#### DATE ASSIGNED **APPLICATION FOR** HISTORIC AREA WORK PERMIT HISTORIC PRESERVATION COMMISSION 301.563.3400

#### **Historic Preservation Commission Preliminary Consultation Report**

Address: 10305 Armory Avenue, Kensington

Proposal: Demolition, two-story rear addition, and various alterations.

A003

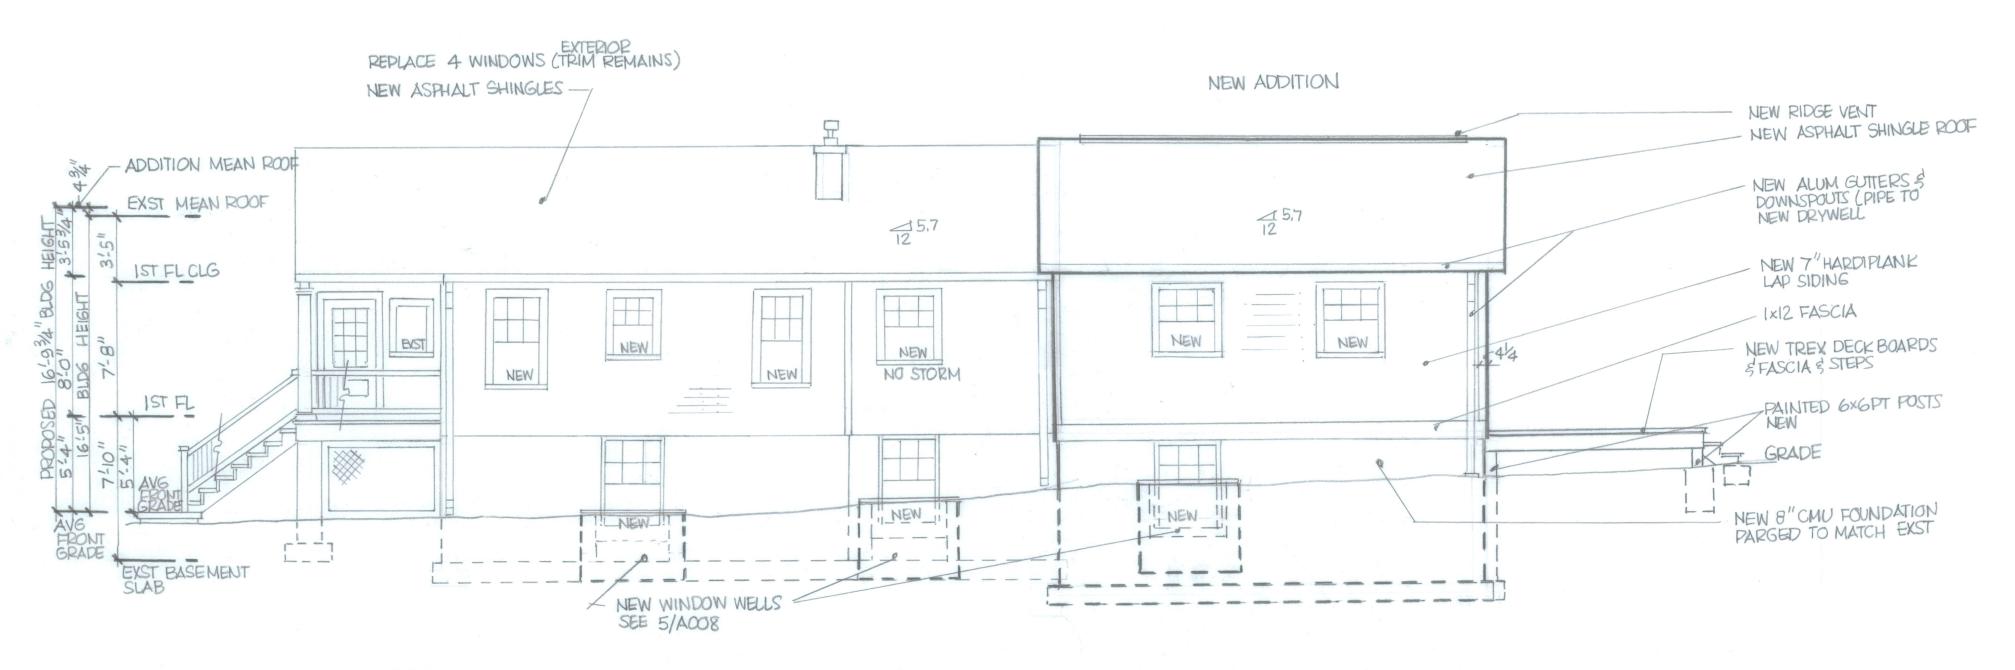
EXISTING HOUSE FINISHES THIS SIDE REMAIN INTACT WITH THE FOLLOWING EXCEPTIONS

- I, POSSIBLE NEW FRONT DOOR
- 2. REPLACE (4) IST FL WINDOWS
- 3. ENLARGE (2) BASEMENT WINDOWS & NEW EGRESS WELLS
- 4. REPLACE ROOF SHINGLE

A006

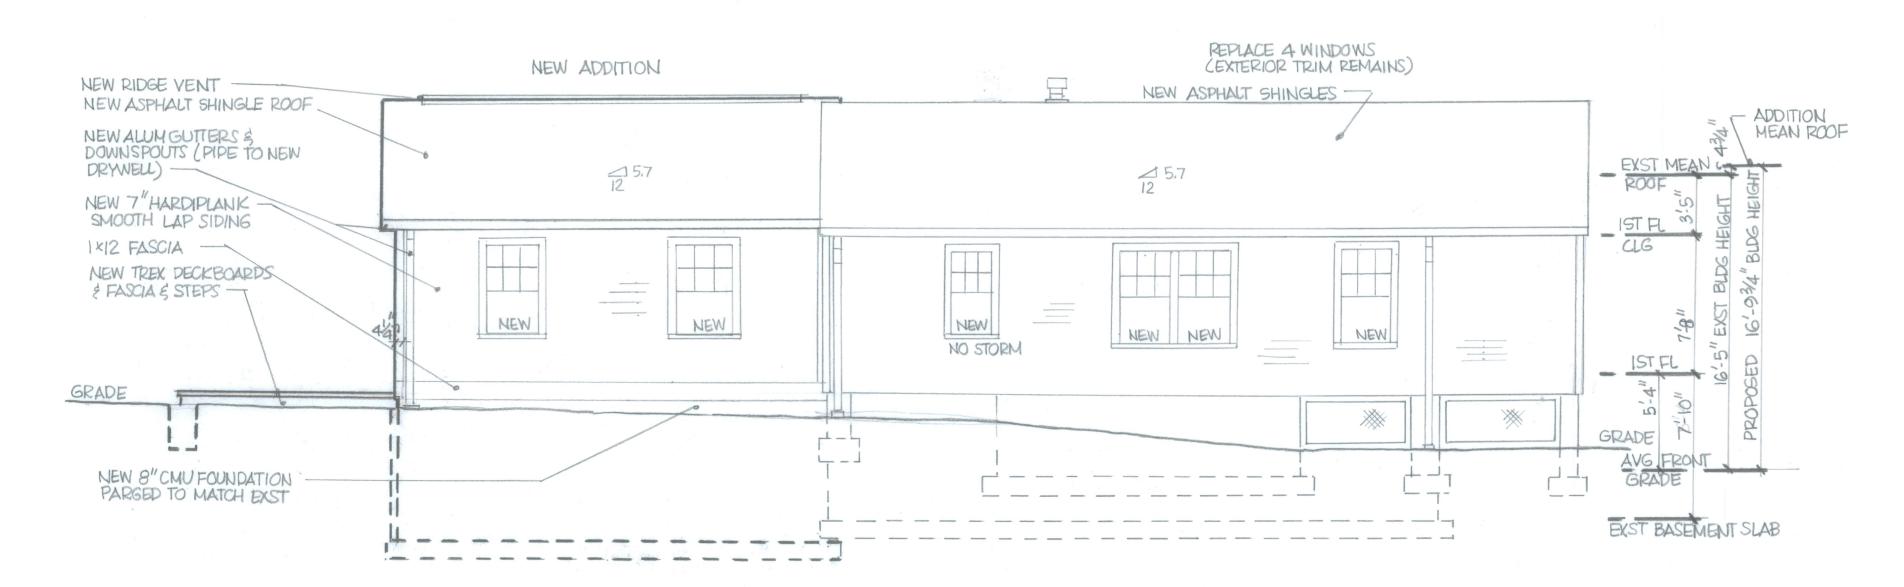
EXISTING HOUSE FINISHES
THIS SIDE REMAIN INTACT WITH
THE FOLLOWING EXCEPTIONS

1. REPLACE (4) IST FL WINDOWS 2. REPLACE ROOF SHINGLES
